# LAUREL HILL

ARCHITECTURAL REVIEW BOARD

July 24, 2014

## Approval Action:

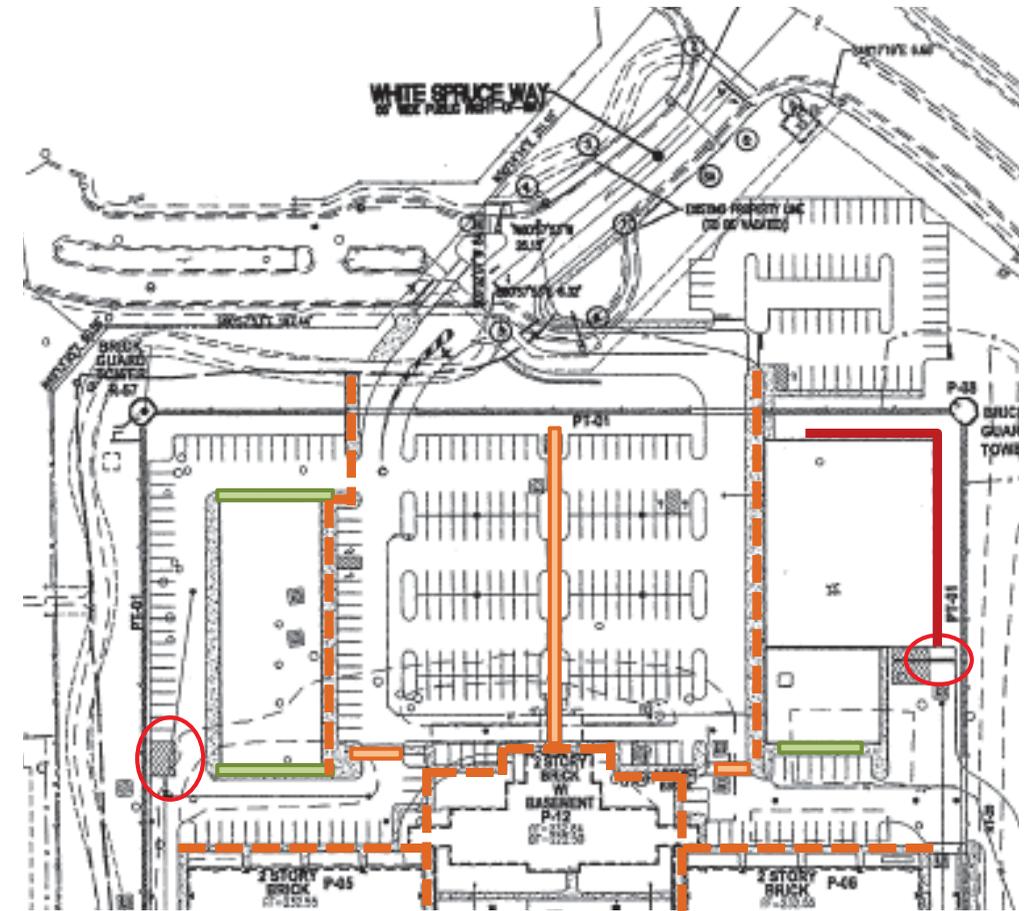
1. Brick on surfaces that would be visible with proper transition between materials.
2. Clarify the pedestrian routes.
3. Dumpster locations and screening.
4. Landscape treatment at end-caps of buildings.
5. Show possible door locations on the elevations, mostly to give scale. Show people for scale purposes.
6. Make the awnings on the shops more colorful.
7. Modify all the renderings to make the glass more reflective/transparent.
8. Create additional view of corner of retail shops.

East Retail Building Front Elevation  
Scale: 1/16"=1'-0"

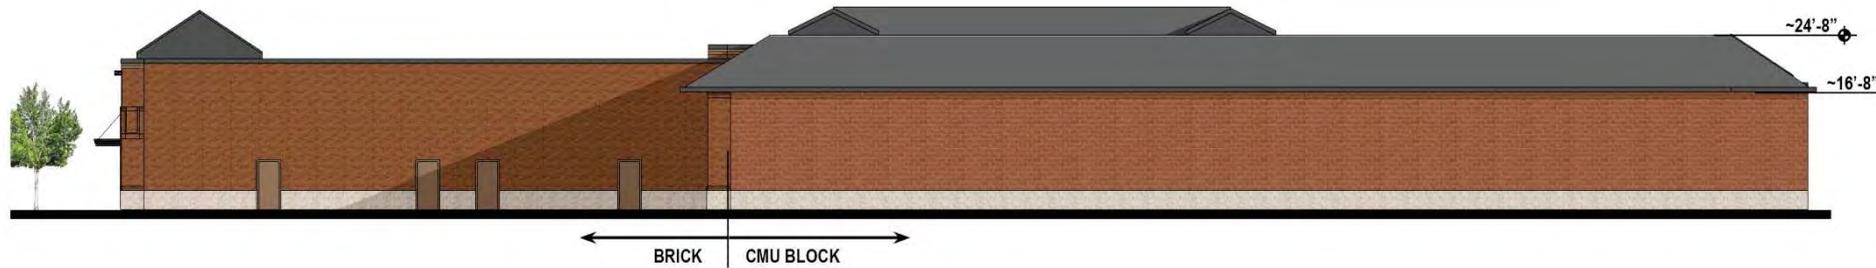
5. Show possible door locations on the elevations, mostly to give scale. Show people for scale purposes.
6. Make the awnings on the shops more colorful.
7. Modify all the renderings to make the glass more reflective/transparent.

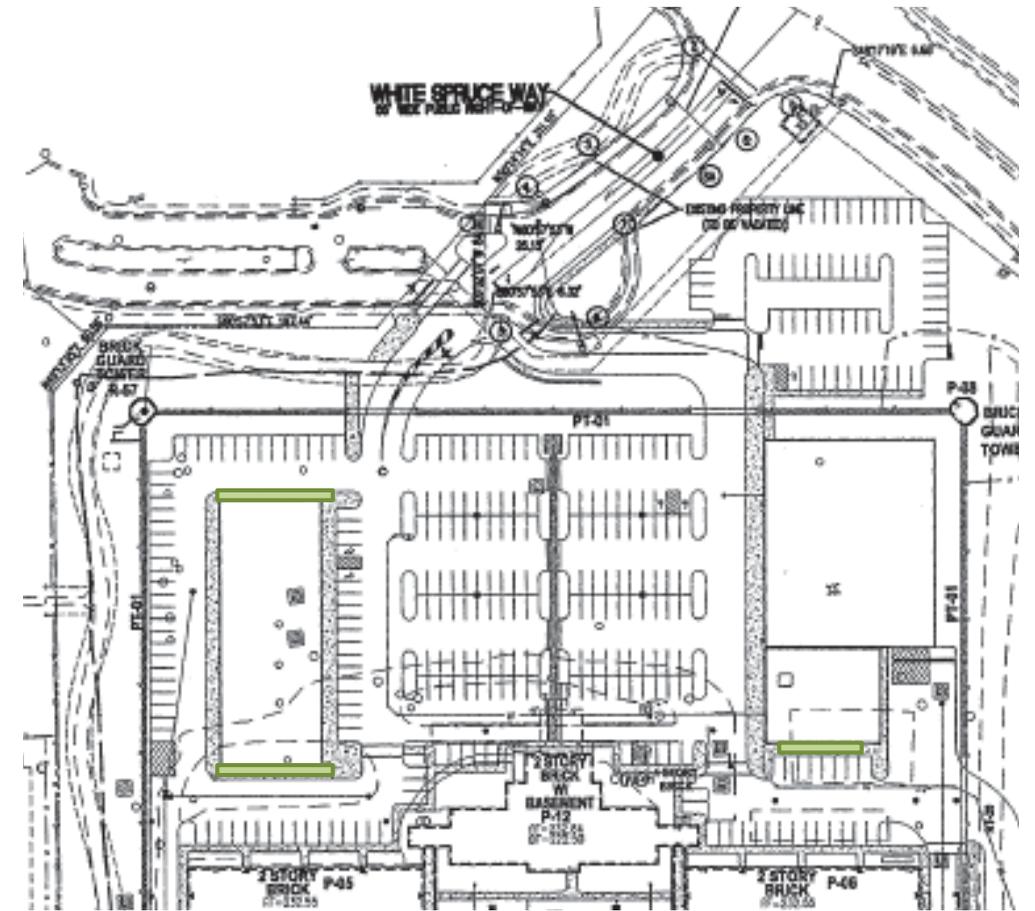
4. *Landscape treatment at end-caps of buildings.*

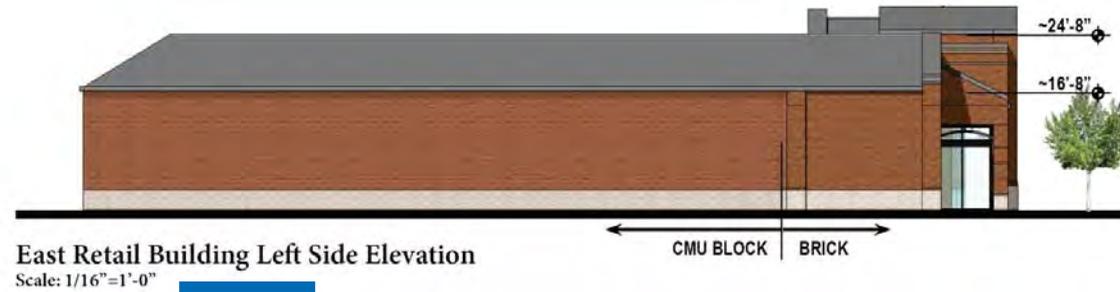
1. Brick on surfaces that would be visible with proper transition between materials.
3. Dumpster locations and screening.
4. Landscape treatment at end-caps of buildings.
5. Show possible door locations on the elevations, mostly to give scale. Show people for scale purposes.
7. Modify all the renderings to make the glass more reflective/transparent.

West Retail Building Front Elevation

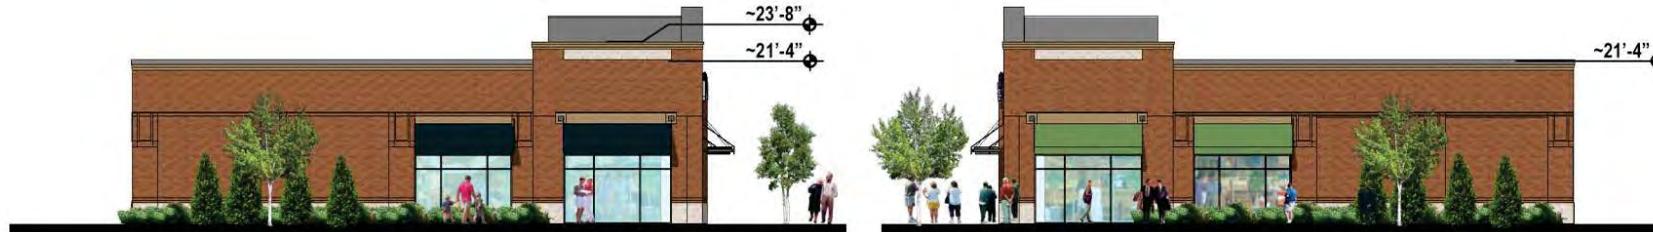
4. Landscape treatment at end-caps of buildings.
5. Show possible door locations on the elevations, mostly to give scale. Show people for scale purposes.
6. Make the awnings on the shops more colorful.
7. Modify all the renderings to make the glass more reflective/transparent.

Proposed Pedestrian Walkway

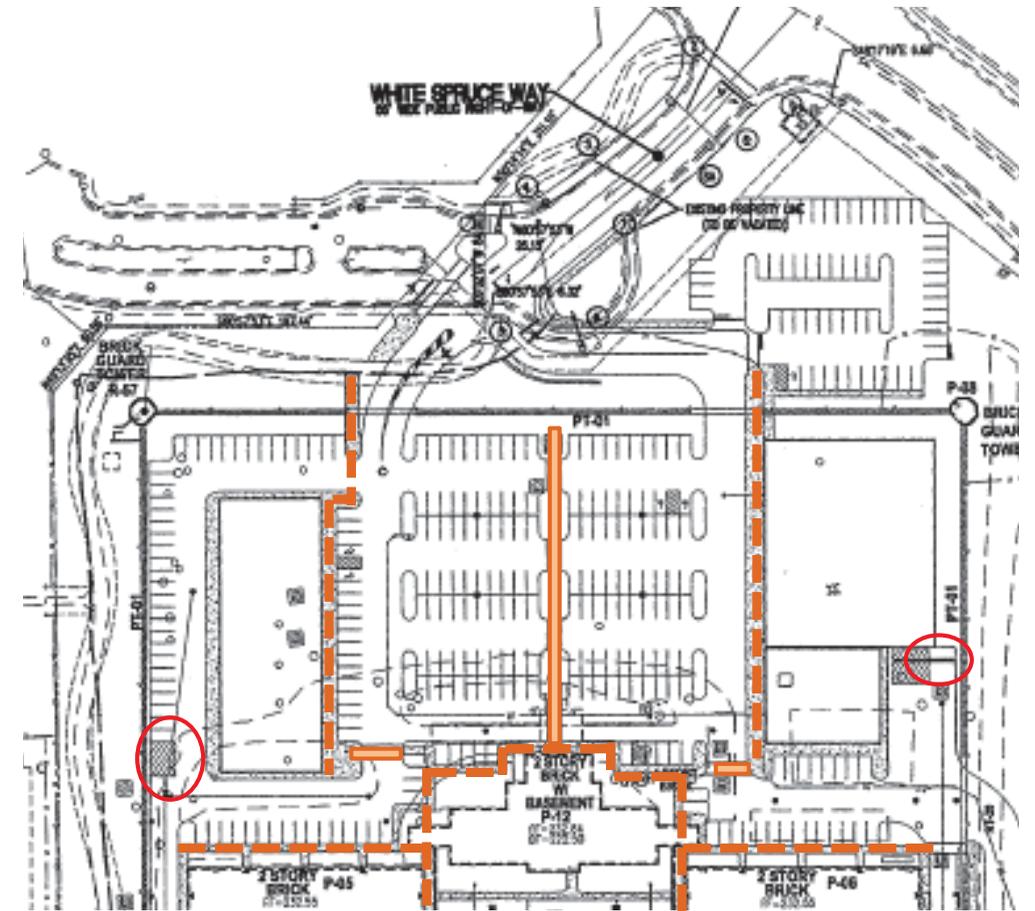
2. Clarify the pedestrian routes.
3. Dumpster locations and screening.
